**STATE OF MARYLAND
CRITICAL AREA COMMISSION
CHESAPEAKE AND ATLANTIC COASTAL BAYS**

Re: Reese Condominium Project

Re: Reese Condominium Project
Crisfield Buffer Exemption Area Ordinance Language

Subject: Reese Condominium
Seventh Street, Crisfield, Maryland
Iott File No. 06-018

EXISTING TO PROPOSED TAKEOFFS IN 100ft BUFFER

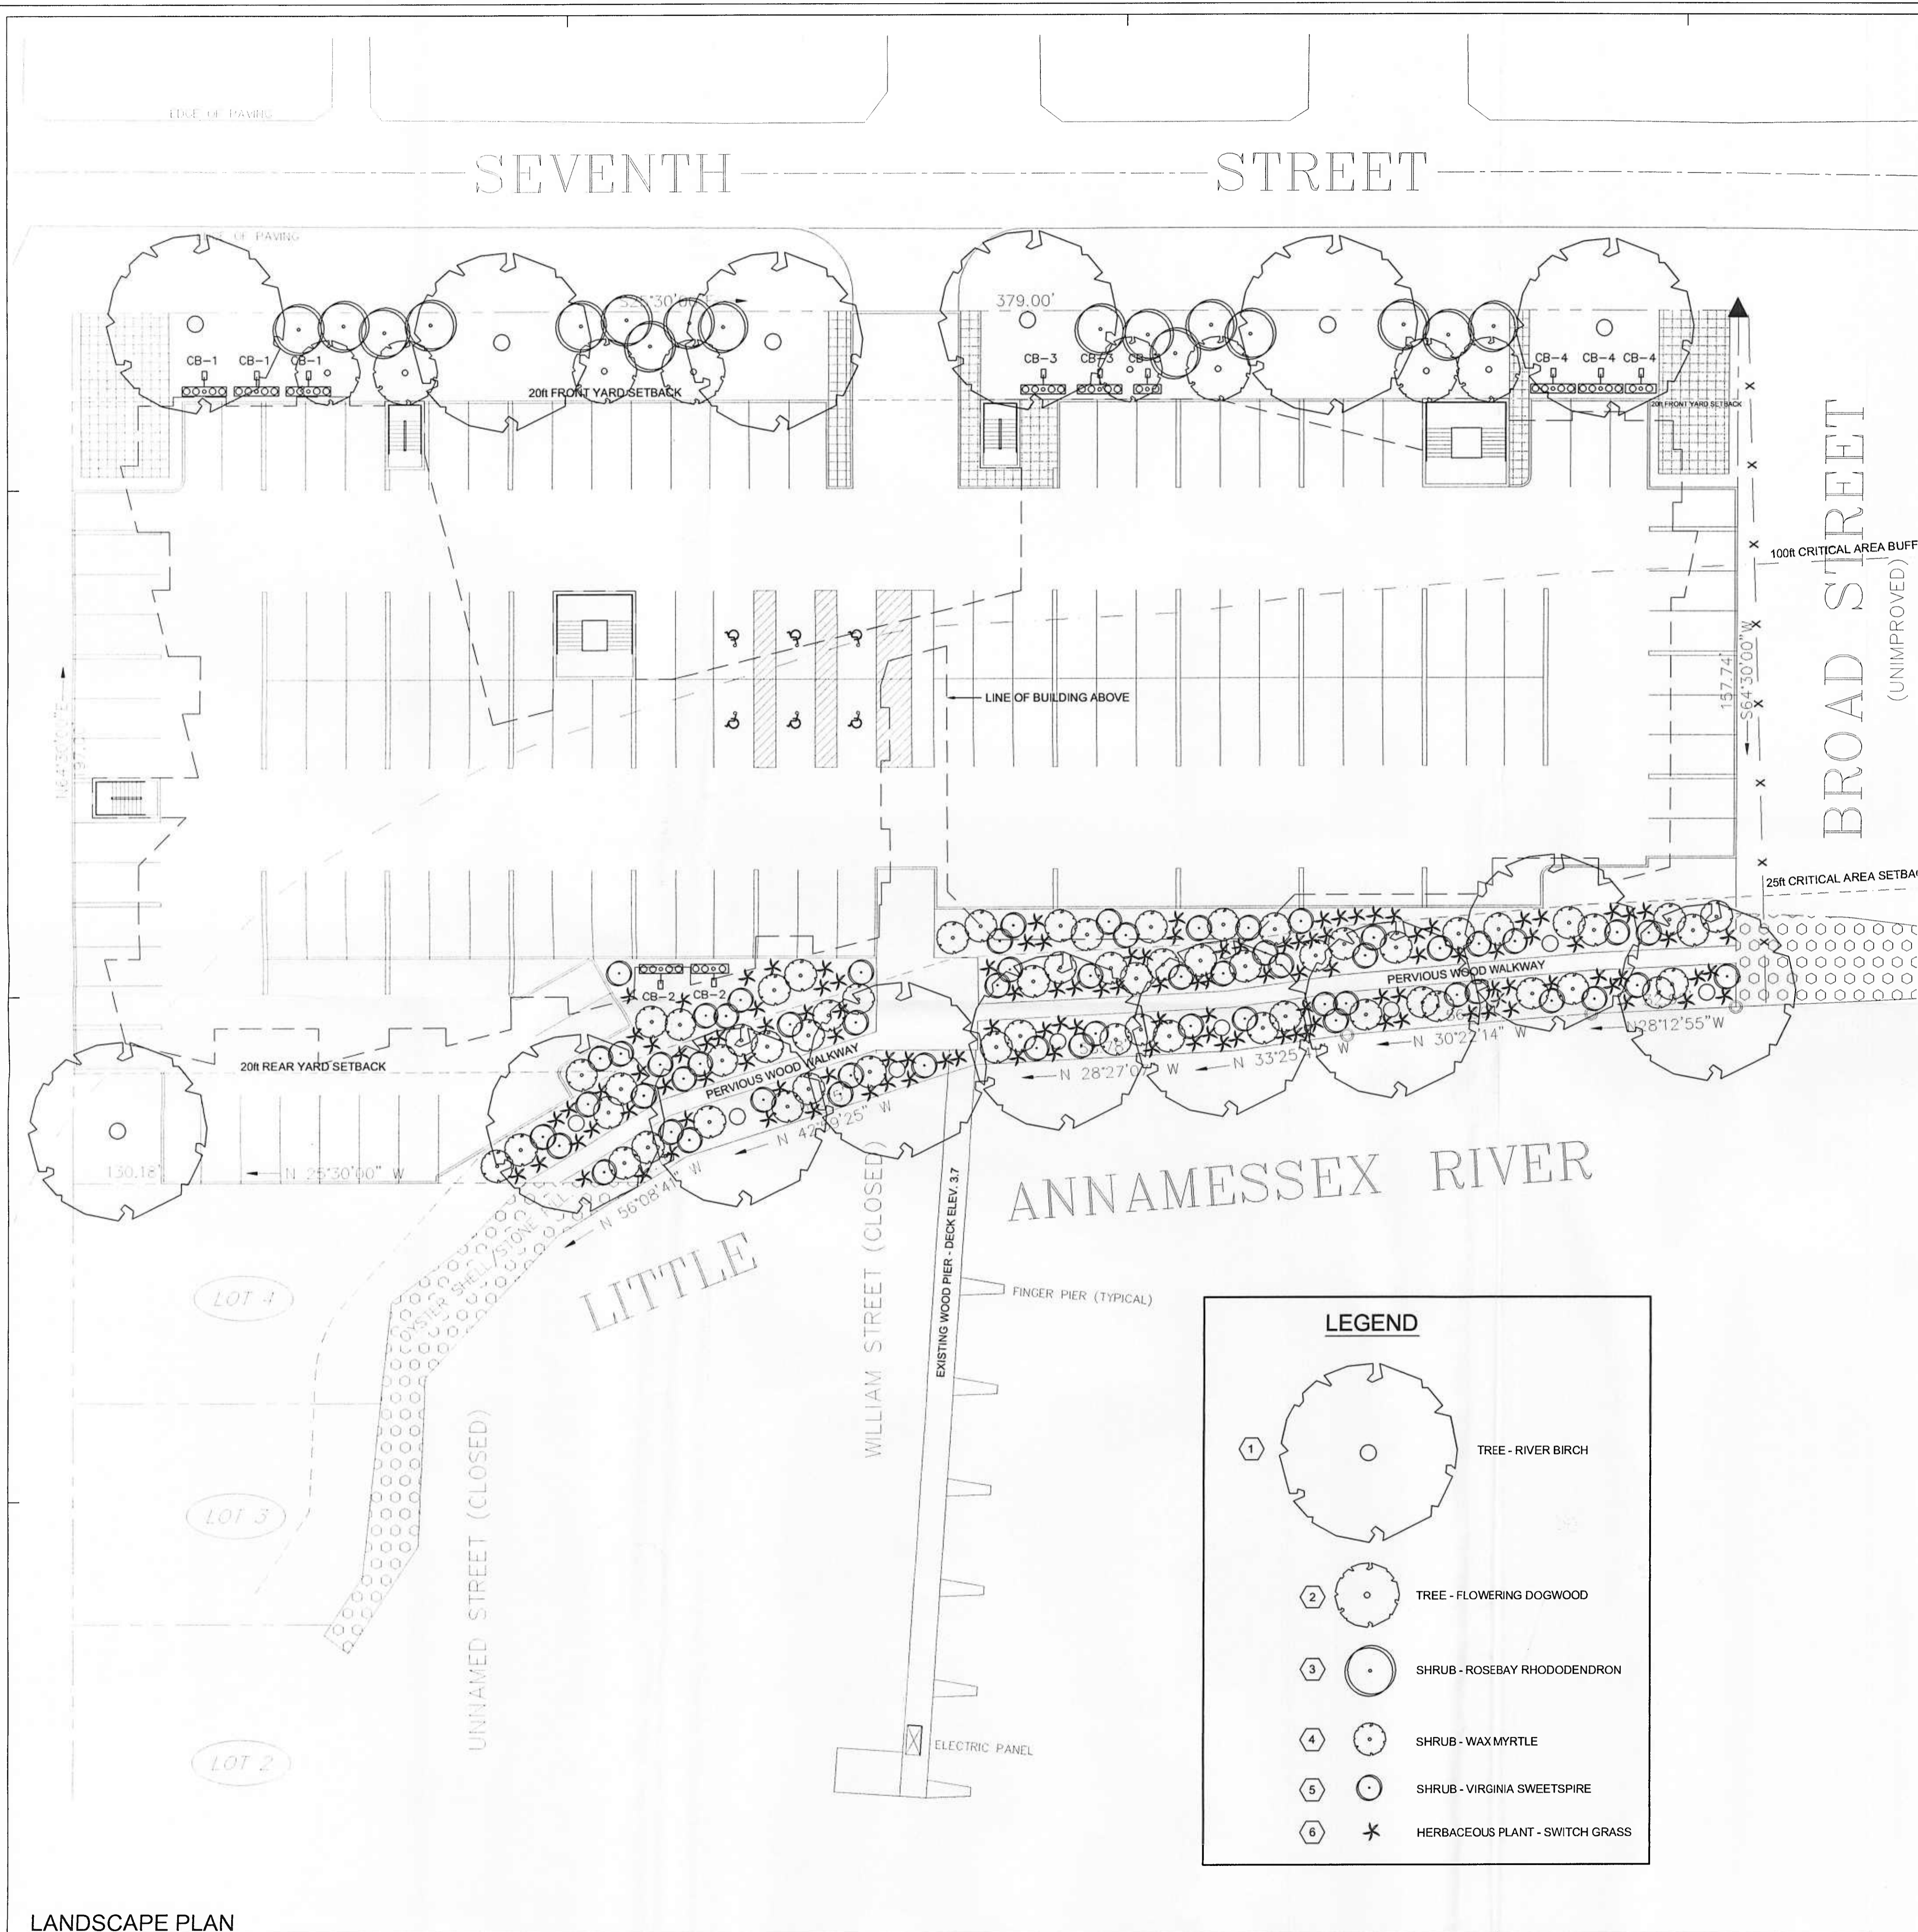
- c. The calculations shown for mitigation in the 100-foot Buffer on sheet L100 are not correct. Crisfield Zoning Code Section 112-108(B)(3)(d) states that natural vegetation of an area twice the extent of the impervious surface created in the BEA shall be planted in a BEA or other location as determined by the city. Given that the proposed paver will cover the same square footage as a completely impervious system, the entire area of development should be included and not discounted. Additionally, the applicant may not claim credit or 1:1 mitigation for existing impervious surface that will be moved elsewhere in the Buffer as there are no provisions for this type of impervious surface trading in the Zoning Code. Based on my calculations, the applicant must provide mitigation for 50,539 square feet.

LANDSCAPE PLAN

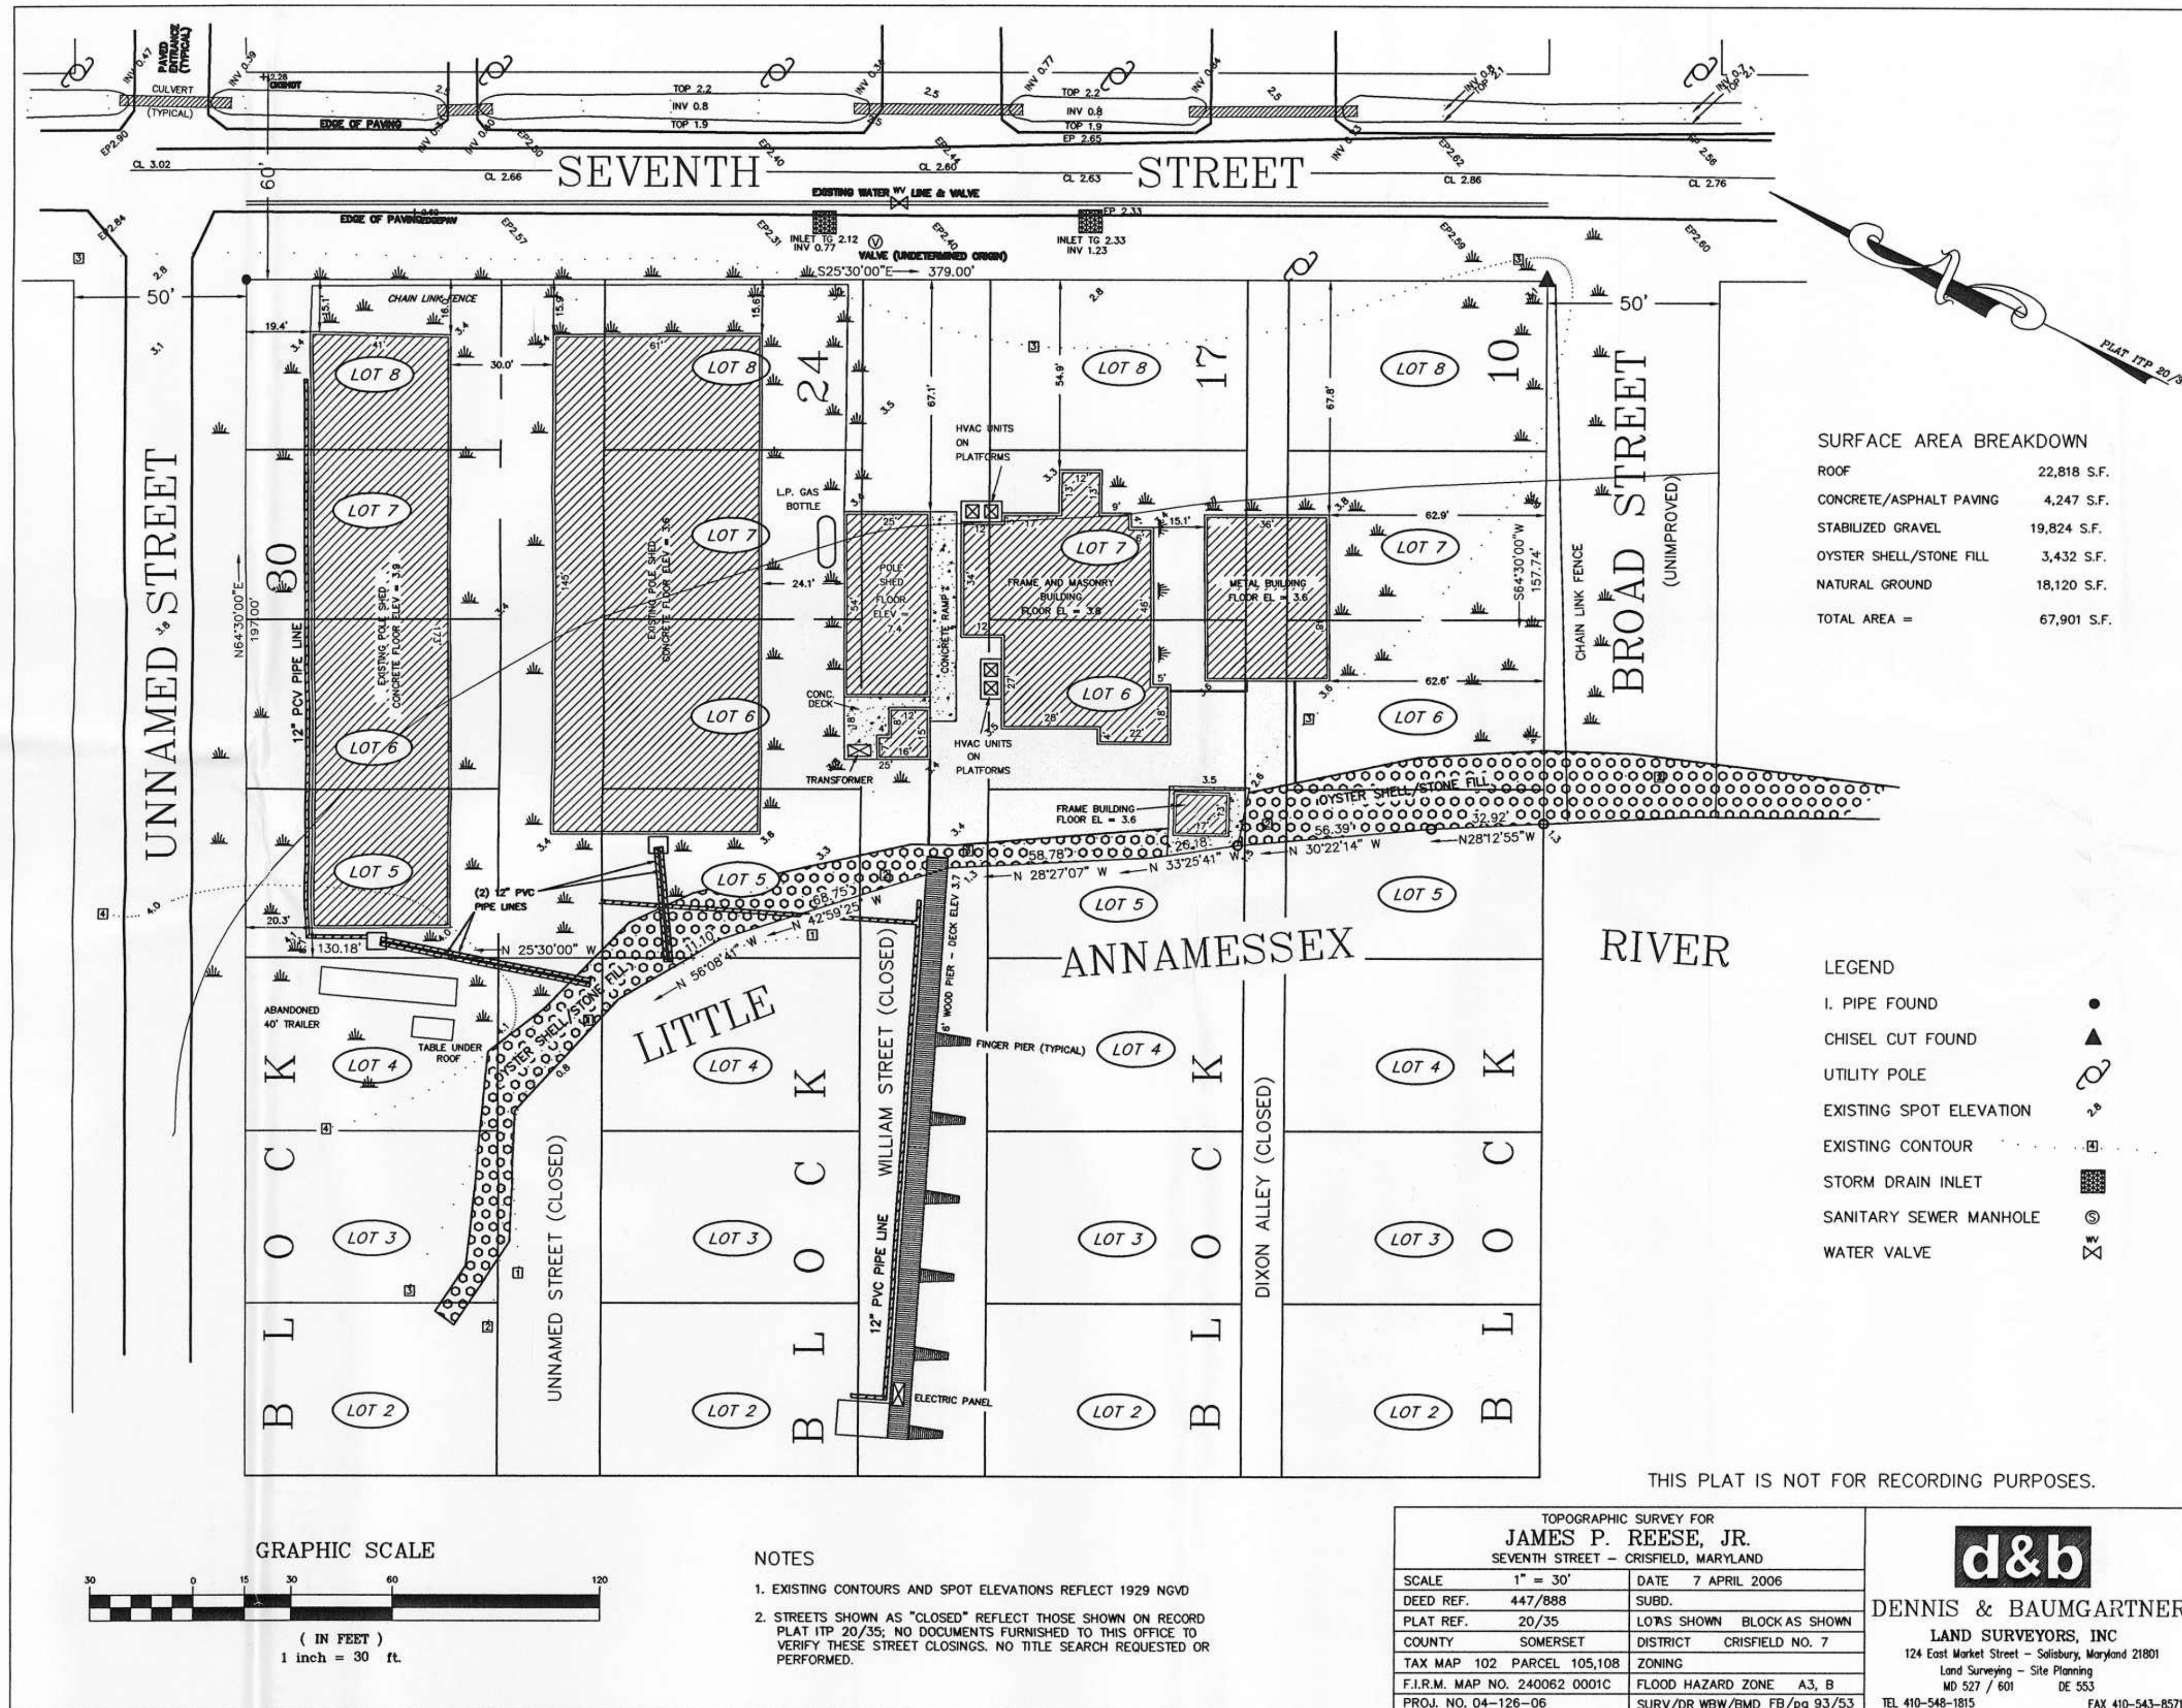
Although not specified, the trees proposed in the landscaping plan should be 1 1/2 to 2-inch caliper. The shrub size should be a minimum of 3 gallons. Please have the applicant amend the landscape schedule to include the species size.

for every 100 linear feet of bufferyard, the following be planted; 5 trees and 10 understory trees/large shrubs and 30 small shrubs and 40 herbaceous plants. Based on my estimate of 250 linear feet, the plantings proposed in the 25-foot setback should be significantly increased in the 25-foot setback.

Today, Mr. Randy Eckert of Iott Architecture delivered a revised planting plan that confirms the proposed plant sizes per the recommendation from Ms. Roberts. As such, this final site plan appears to comply with all of the requirements of the City's Critical Area Ordinance. Iott Architecture will be delivering that revised plan to the City today and I have a copy to forward to the Critical Area Commission staff.
